YANAGAWA et al. Appl. No. 10/768,192 June 22, 2006

AMENDMENTS TO THE DRAWINGS

REMARKS/ARGUMENTS

Fig.4

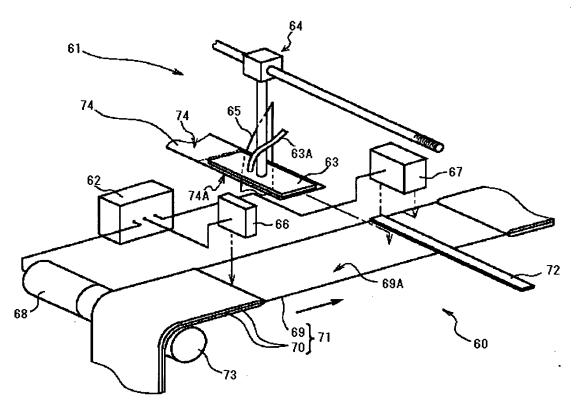
Addressing the issues raised in the outstanding Action in the order presented, it is proposed to amend Figures 4 and 5 to label them as "Prior Art" as the examiner requests. Replacement sheets are provided with this response.

With regard to no. 2, reference sign "63A" is not explicitly discussed in the description however in the context of the overall disclosure and the prior art referenced in these figures the nature and character of reference sign 63A will be apparent. Submitted with this response is a substitute specification attending to this and other adjustments requested by the examiner and made by applicants.

The relevant passages on pages 4 and 5 (referenced to the text as filed) have been amended in order to include a discussion of reference sign 63A. As this information pertains to acknowledged prior art, it is not critical to the disclosure of the present application. However, basis for these changes will be apparent considering the overall discussion presented relative to these drawings.
